IN THE UNITED STATES PATENT AND TRADEMARK OFFICE
BEFORE THE HONORABLE BOARD OF PATENT APPEALS AND
INTERFERENCES

Application No.: 10/500,713

For: METHOD FOR MANUFACTURING FILAMENTS FROM AN
OPTICALLY ANISOTROPIC SPINNING SOLUTION AND AIR GAP
SPINNING DEVICE

BRIEF ON APPEAL

Fig. 6

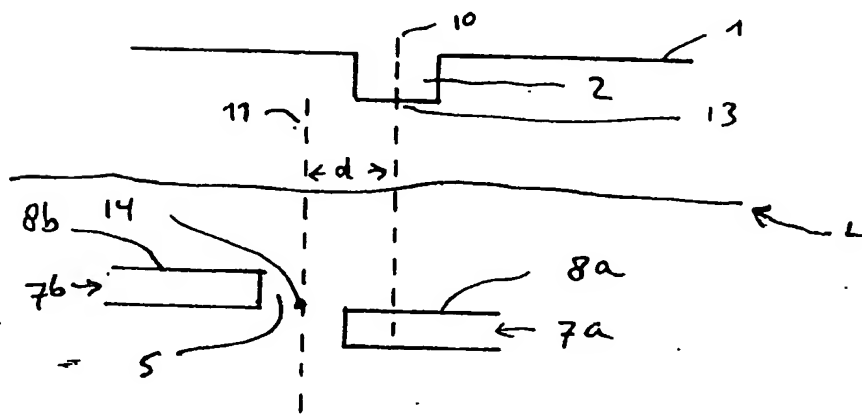
achieved by the embodiment described in paragraph [0043] and depicted in Figure 6. FACTS 36–44. Paragraphs [0010] and [0011] contrast the effects of coagulant streams flowing from adjacent discharge openings that are at the same level and of coagulant streams flowing from edges of adjacent discharge openings that are at different levels. FACTS 45–49, 7–12.

Moreover, as discussed above, paragraph [0009] teaches that paragraphs [0010] and [0011] explain why the configuration depicted in Figure 6 leads to no substantial coagulation bath motion. FACTS 36–44. Figure 6 depicts edges of the opening being at different levels. FACT 26. Paragraphs [0010] and [0011] explain that discharge openings with edges at different levels leads to a calm coagulation bath surface. FACTS 45–49, 7–12. Thus, paragraphs [0009] to [0011] teach that the slot/diaphragm configuration depicted in Figure 6 implicitly corresponds to the discharge opening with edges at different levels discussed in paragraphs [0010] and [0011]. Because the discharge opening is

Original Figure 2

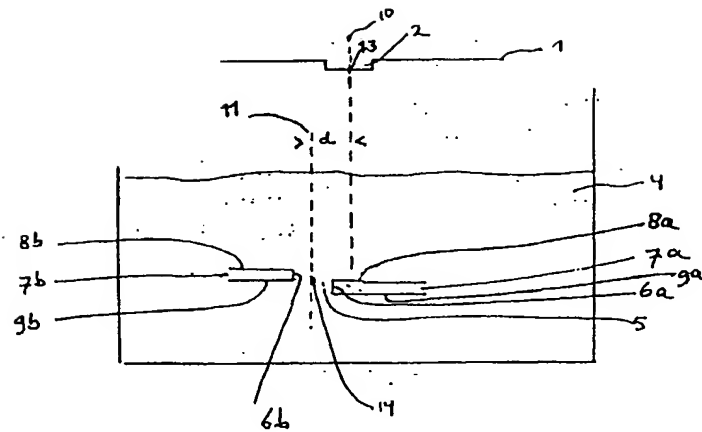
As has been repeatedly discussed, Applicants respectfully submit that the outermost line defining the boundary of the bottom of the bath in original Figure 2 was drawn in error, and this boundary should have been drawn as being contiguous with the bottoms of the slots 7a and 7b. This is the issue at dispute. However, regardless, Applicants note that original Figure 2 *also* did not show the "discharge opening" in the bottom of the bath. Paragraph [0003] of the specification as originally filed clearly discussed the "discharge opening[]" in the bottom of the coagulation bath." The Office Action mailed February 4, 2008, agrees that "there must be an opening in the bottom of the coagulation bath shown in the original Figure 2." Office Action mailed February 4, 2008, page 6.

Therefore, regardless of whether *the slot or diaphragm* is located at the bottom of the bath, a *discharge opening* is clearly located at the bottom of the bath. A hypothetical Figure 2, showing the slot or diaphragm as was shown in original Figure 2, but also including a discharge opening at the bottom of the bath, is shown below.

Hypothetical Figure 2

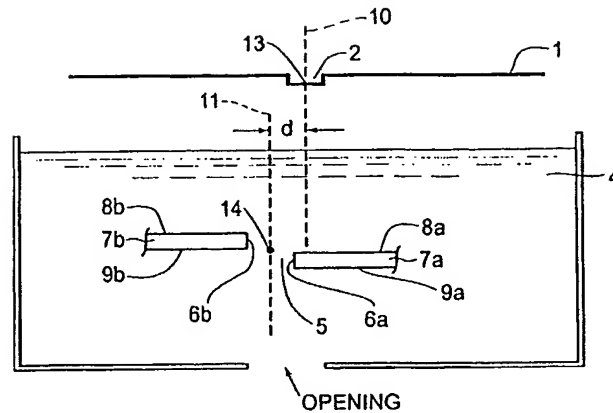
Applicants strongly stress that this Figure is hypothetical, and is presented only for the purposes of argument herein.

discharge opening as in Amended Figure 2, or (2) the slot or diaphragm is located some distance above the discharge opening as in Hypothetical Figure 2.

In arguments one and three, applicant argues that the geometry of the slot is clearly the geometry of the coagulation bath's bottom. This argument is not persuasive. The examiner notes, for example, that hypothetical Figure 2 also reasonably is understood to provide the required geometry. Further, the examiner submits that the linkage of the word "geometry" does not expressly, implicitly, or inherently, link the location of the slot or diaphragm and the discharge opening itself. Further still, the examiner points again to paragraphs [0018] and [0029] as set forth above, which demonstrates that the bottom of the coagulation bath and the slot or diaphragm do not "necessarily" correspond to each other as set forth in the arguments.

Amended Figure 2

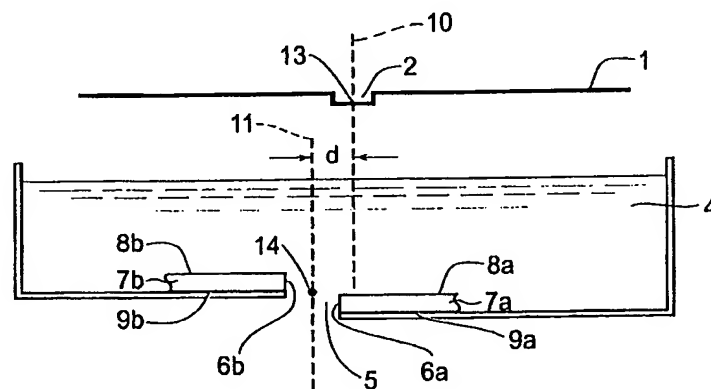
The amendment to the drawings filed April 30, 2007 is objected to under 35 U.S.C. 132(a) because it introduces new matter into the disclosure. 35 U.S.C. 132(a) states that no amendment shall introduce new matter into the disclosure of the invention. The added material which is not supported by the original disclosure is as follows: Figure 2 has been modified to show the plates and the slot or diaphragm at the bottom of the coagulation bath. This objection may be overcome by pointing to the location in the original disclosure where support for this amendment may be found. Otherwise, applicant is required to cancel the new matter in the reply to this Office Action.

examiner submits that such an argued connection between the slot or diaphragm and the discharge opening only appears feasible after viewing revised Figure 2 (which the examiner maintains also contains new matter) and that such a connection is not expressed, implied or inherent in the original disclosure.

positioned at the bottom of the coagulation bath", as shown in replacement Figure 2 filed April 30, 2007, does not appear to be supported by the original disclosure. Claims 3-7 are rejected as dependent claims. This rejection may be overcome by pointing to the location in the original disclosure where support for this limitation may be found.

As an initial matter, applicant argues on pages 2-4 that either hypothetical Figure 2 or amended figure 2 must be correct. The examiner submits that there is no disagreement with the fact that the original specification provides support for an opening at the bottom of the coagulation bath. The issue at dispute is whether the original disclosure expressly, implicitly or inherently discloses that the slot or diaphragm is the same as the discharge opening. In this regard, the examiner maintains the objection to amended Figure 2 and the 35 USC 112 first paragraph rejection of the claims.

The examiner submits that the arguments take portions of the specification and concludes that they must be linked such that amended Figure 2 is the clear and only possible result. These arguments are not persuasive. As set forth above, the examiner has provided citations from the specification itself, that do not require forming linkages between disparate sections of the specification, that makes it clear the original specification does not clearly convey or require that the slot or diaphragm is the same as the discharge opening. Therefore, while the sections presented in the arguments are interpreted in view of amended Figure 2, the ability to make such an interpretation itself, no matter how tenuous, after presenting amended Figure 2, does not show that amended Figure 2 or the claims based on amended Figure 2 are

Applicants have repeatedly argued throughout prosecution that a person having ordinary skill in the art would understand that "Amended Figure 2" is necessarily disclosed by the specification as originally filed. In further support for these arguments, the following four *new* arguments are presented. Applicants respectfully request full and proper consideration of each of the following new arguments.

(1) Paragraph [0003] of the present specification as originally filed states that "the extent to which the coagulation bath surface is in motion is highly dependent on the geometry of the coagulation bath's *bottom*" (emphasis added). Therefore "the extent to which there is motion at the coagulant surface can be reduced substantially by introducing *the geometry of the present invention*" (emphasis added). Applicants respectfully submit that the description of the "slot or diaphragm" throughout the present specification is clearly the "present invention" referenced in paragraph [0003]. See, for example, paragraphs [0004] and [0005] describing the geometry of the slot or diaphragm under "Summary of the Invention." Therefore, the geometry of the "slot or diaphragm" is clearly the "geometry of the coagulation bath's *bottom*" as described in paragraph [0003]. Thus, the slot or diaphragm is located at the bottom of the bath, in accordance with Amended Figure 2.

Accordingly, for these four reasons, as well as all of the reasons discussed previously throughout prosecution, a person having ordinary skill in the art would have understood that Amended Figure 2 is necessarily implicitly disclosed by the specification as originally filed. Thus, Amended Figure 2 does not constitute new matter.
